Crown Street Primary School

NON MATERIAL AMENDMENT APPLICATION BOOKLET

C3-AKL-A180-RP-XX-0001
OCTOBER 2022
REVISION P02

Section B
1:25

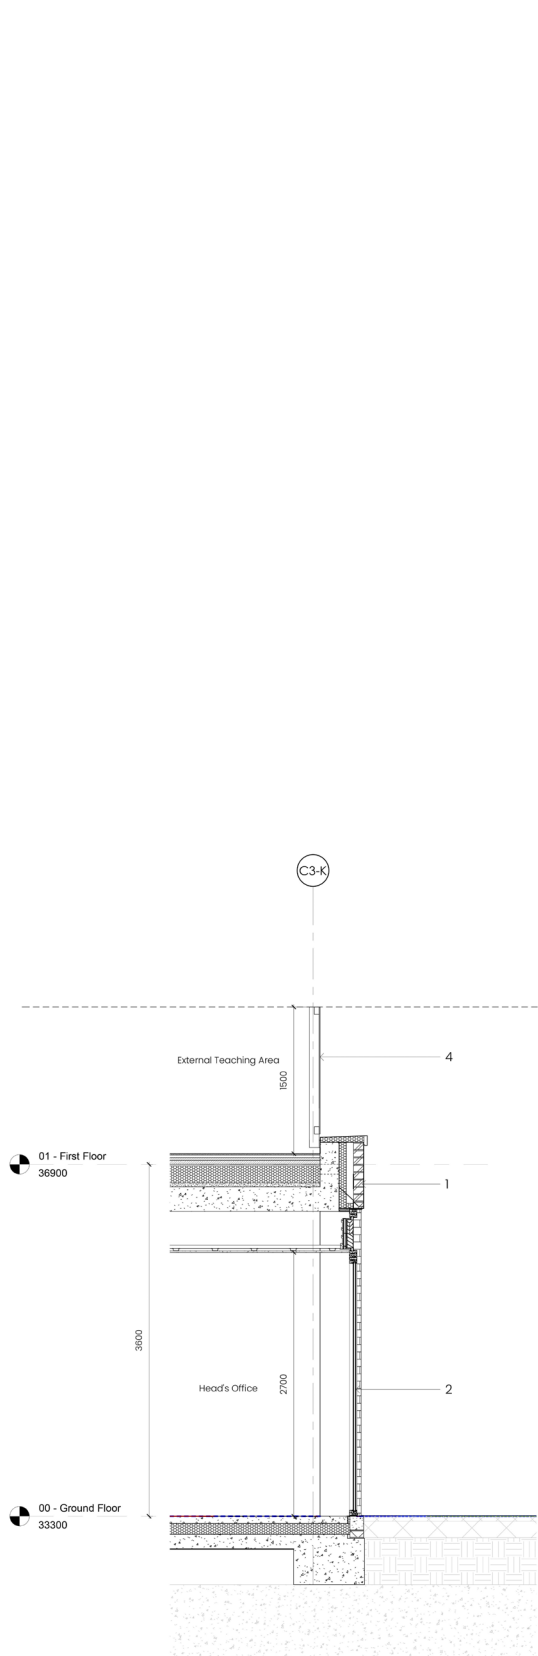
1. Facing Brickwork
2. Capped Stick-Built aluminium or composite aluminium Curtain Wall or top hung operable windows, bronze finish
3. Aluminium or composite aluminium Glazed Doors (door height 2000m) to Capped Stick-Built Curtain wall system, bronze finish
4. Perforated metal panels balustrade, bronze finish
5. Brick Faced Concrete Upstand
6. Louvre System, bronze finish
7. Perforated metal panels infill (antislip - anti-trap), bronze finish
8. Bronze finish metal plinth

North Elevation Extract - Detail B
1:25

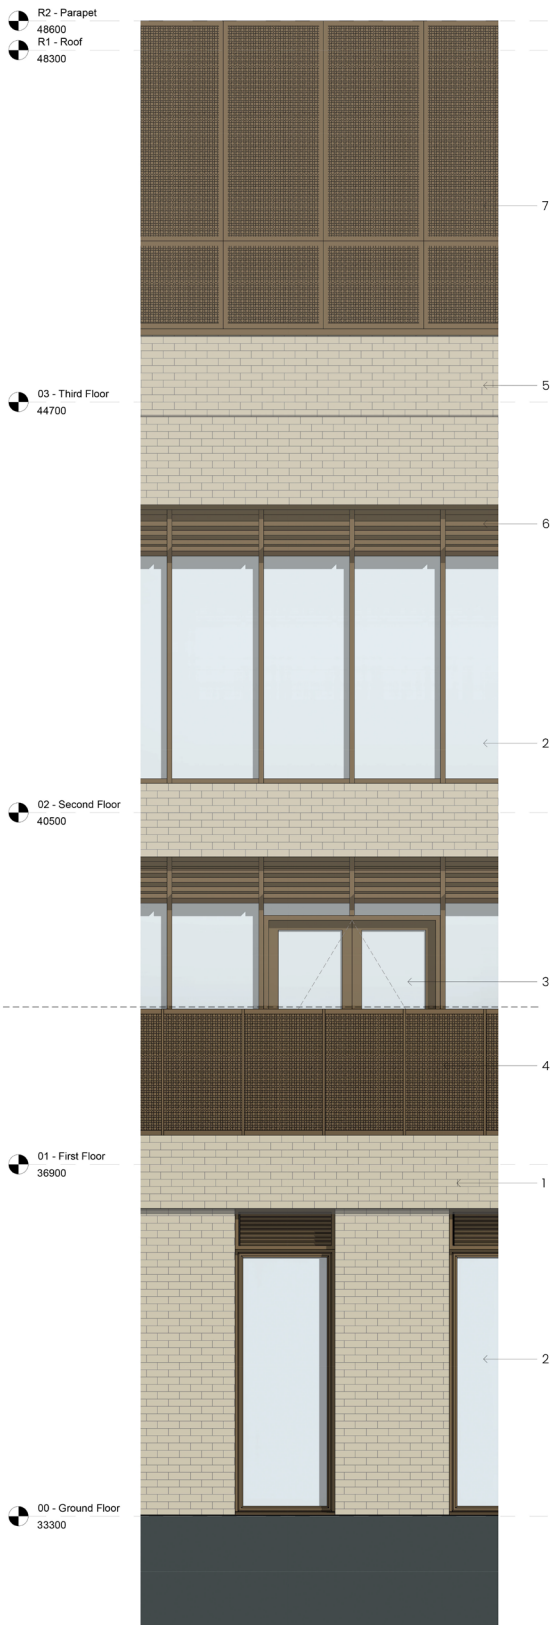
- 2. Capped Stick-Built
- 3. Capped Stick-Built aluminium or composite aluminium
- 4. Curtain Wall or top hung operable windows, bronze finish
- 5. Aluminium or composite aluminium Glazed Doors (door height 2000) to Capped Stick-Built Curtain wall system, bronze finish
- 6. Brick Faced Concrete Upstand
- 7. Soffit, metal panels with bronze finish
- 8. Louvre System, bronze finish
- 9. Perforated metal panels infill (anticlimb - anti-trap), bronze finish
- 10. Bronze finish metal plinth
